AGENDA
City of Salmon Arm
Development and Planning Services
Committee

Tuesday, July 4, 2023
8:00 a.m.
Council Chambers, City Hall
500 – 2 Avenue NE
Salmon Arm, BC

Subject: Official Community Plan Amendment Application No. 4000 – 54 and Zoning Amendment Application No. 1266

Legal: Lot 2, Section 12, Township 20, Range 10, W6M, KDYD, Plan EPP106795
 Civic Address: 1421 17 Street SE
 Agent: Franklin Engineering Ltd. (Samantha Mitchell)
 Owner: Jesse & Emily Beagle

Project No. EG1892
Version: V1
Date: 04/17/2023
Drawing Title: SITE PLAN

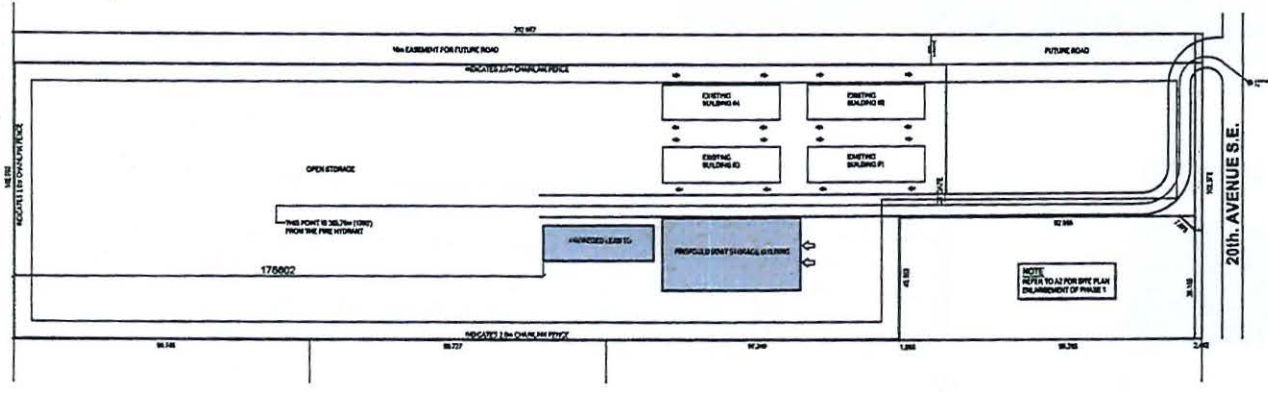
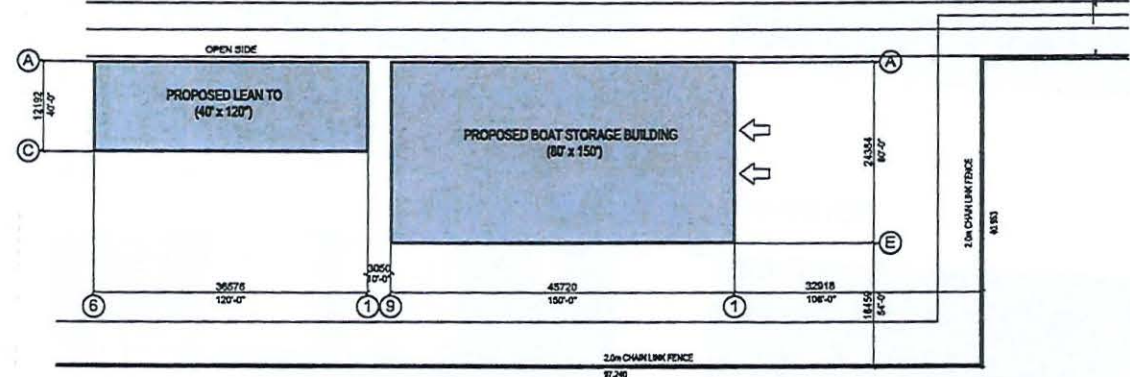
A future road network has been planned affecting the subject parcel to support the future development and expansion of the Industrial Park (Appendix 6), and as such is once again a key element of this proposal. The proposal includes a 10 m wide strip along the east parcel line for the future road network. Given road construction is still premature at this time but recognizing the importance of the future road plan, the registration of a Section 219 road reserve covenant was required to secure the future road alignment. Said covenant is registered on Title and another Section 219 road reserve covenant is not required. Staff note that road dedication and construction would be triggered by future subdivision.

CITY OF SALMON ARM		20m R/W Rural Collector Road Cross-Section	
No.	Revision	Date	Date
A.	ISSUED FOR APPROVAL	07/14/16	10-11-2016
			Approved City Engineer
			SPECIFICATION DRAWING No. RD-8

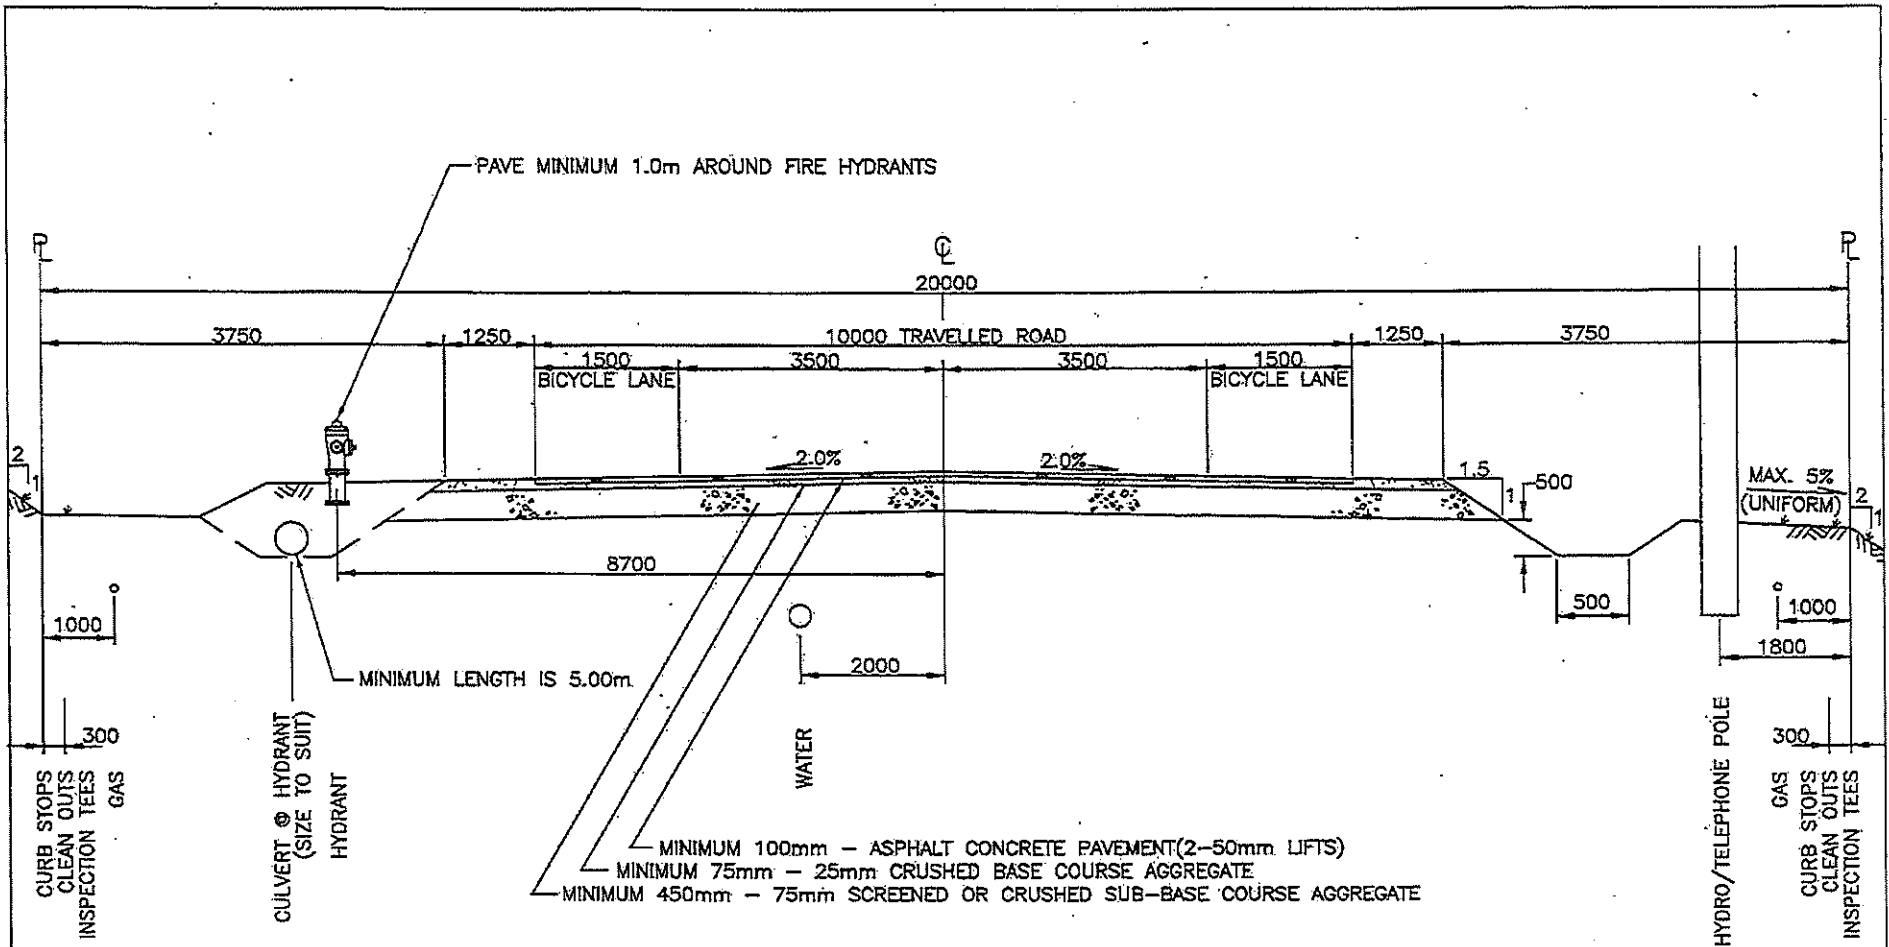
50 Street NW adjacent to the subject parcel is required to be upgraded to a Rural Collector Road Standard (Appendix 7, RD-8). It has been identified in the OCP for a Bike Route (OCP Map 12.2), as well as within the City's Active Transportation Network Plan. Available records show that there is sufficient road right-of-way to accommodate the required upgrades.

The Official Community Plan (Map 12.2) currently includes this section of road in the Cycle Network Plan (See appendix A); therefore, staff do not support waiving the requirements of the SDSB.

The Engineering Department recommends that the requested variance to waive the requirement for upgrade 50 Street NW to the Rural Collector Road standard (RD-8) be denied.
